# United States Patent and Trademark Office

APPLICATION NO.	FILING DATE	FIRST NAMED INVENTOR	ATTORNEY DOCKET NO.	CONFIRMATION NO.	
10/722,906	11/25/2003	Kristofor M. Hallee	014881-000196 2928		
24239	7590 11/20/2006		EXAMINER		
MOORE & V P.O. BOX 137	AN ALLEN PLLC		FIDEI, DAVID		
	igle Park, NC 27709		ART UNIT	PAPER NUMBER	
•			3728	3728	
			DATE MAILED: 11/20/2006

#### **DETAILED ACTION**

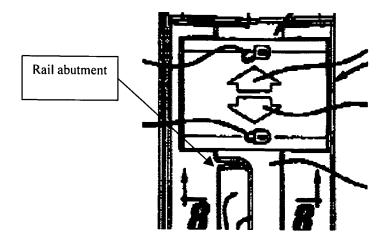
- 2. Claim 47 is rejected under 35 U.S.C. 102(e) as being anticipated by Streich et al (Patent no. 6,755,302). A tool retaining system is disclosed comprising an outer casing 22, 24 hingedly attached housing members that open and close along a hinge, each of the housing members being defined by a base and a plurality of upstanding walls. The outer casing being secured by a split rail latch 90, 94, 96 wherein at least one housing members includes at least one abutment preventing the latch from sliding to an end of the split-rail, see diagram below.

In the above representation the latch 92 can slide onto rail 96 as this rail is aligned with rail 90. However, when the closure is ajar and slightly open it stands to reason that the rails 96 and 94 are not aligned, with a larger gap 98 the latch 92 is inhibiting from sliding to the closed position. Hence at least one housing members includes at least one abutment preventing the latch from sliding to an end of the split-rail in as much as is disclosed and claimed.

4. Applicant's arguments have been fully considered but they are not persuasive. With regard to the split rail construction of claim 47 applicant finds no abutment. While the case walls will stop travel of the latch from sliding, it is also apparent that alignment of the rails 94, 96 permits sliding of the latch as opposed to a position where the cover, or one case section, is slightly open. As the Federal Circuit has observed, "the name of the game is the claim," *In re Hiniker Co.*, 150 F.3d 1362, 1369, 47 USPQ2d 1523, 1529(Fed. Cir. 1998). And in so far as claim 47 sets forth Streich et al discloses at least one housing member including at least one abutment preventing the latch from sliding to an end of the split-rail.
